May 26, 2017

Stuart Spencer
Associate Director, Office of Air Quality
Arkansas Department of Environmental Quality
5301 Northshore Drive
North Little Rock, AR 72118-5317

**Re: Technical Information Regarding BART Limits for White Bluff
and Reasonable Progress Limits for Independence**

Cost-Effectiveness vs. Date of Enforceable Shutdown

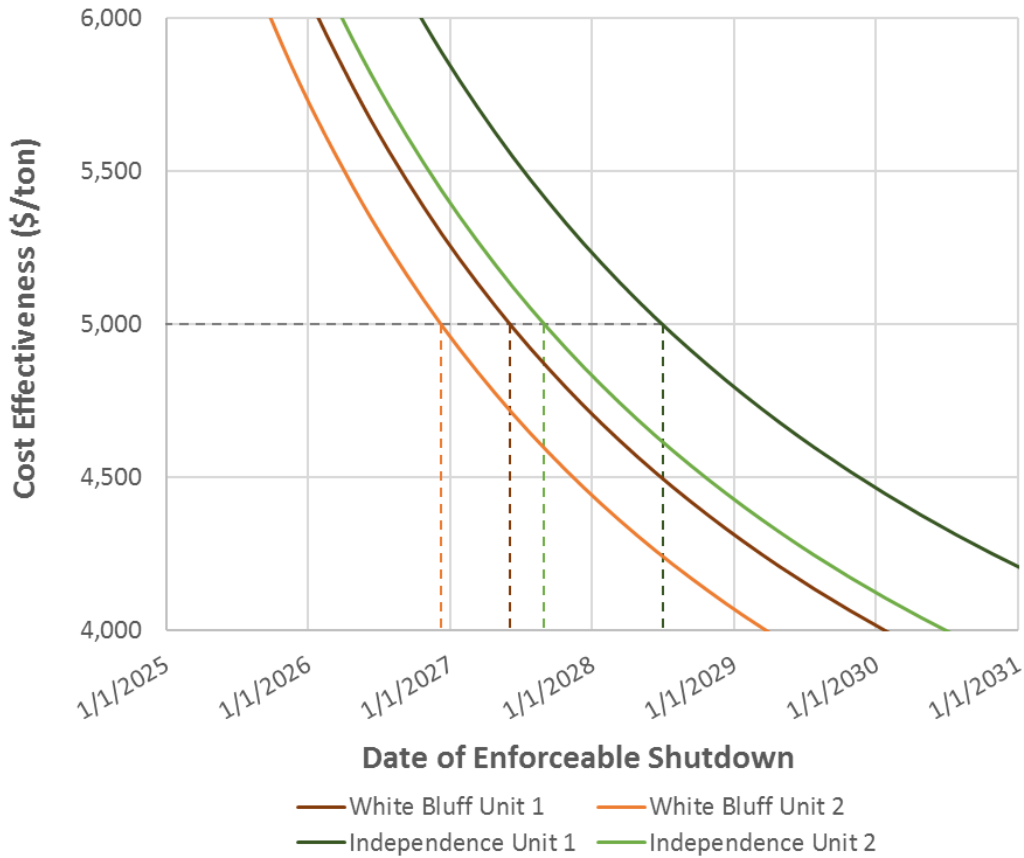
On the following page, Figure 1 shows how cost-effectiveness for new scrubbers at White Bluff Units 1 and 2 and Independence Units 1 and 2 varies with the remaining useful life of each unit. Figure 1 highlights the point at which cost-effectiveness values for new scrubbers on each unit reach \$5,000/ton, which is a common informal threshold for cost-effectiveness in regional haze decision-making.⁸ For BART, cost-effectiveness cannot, of course, be evaluated in isolation. Here, given the substantial visibility benefits that would result from scrubbers, controls should be deemed cost-effective at \$5,000/ton, if not above.⁹

Application of this threshold leads to the conclusion that scrubbers remain cost effective for the units in question unless there is a legally enforceable requirement for them to retire no later than the following dates:

| White Bluff Unit 1 | June 5, 2027 |
| White Bluff Unit 2 | December 10, 2026 |
| Independence Unit 1 | July 1, 2028 |
| Independence Unit 2 | September 1, 2027 |
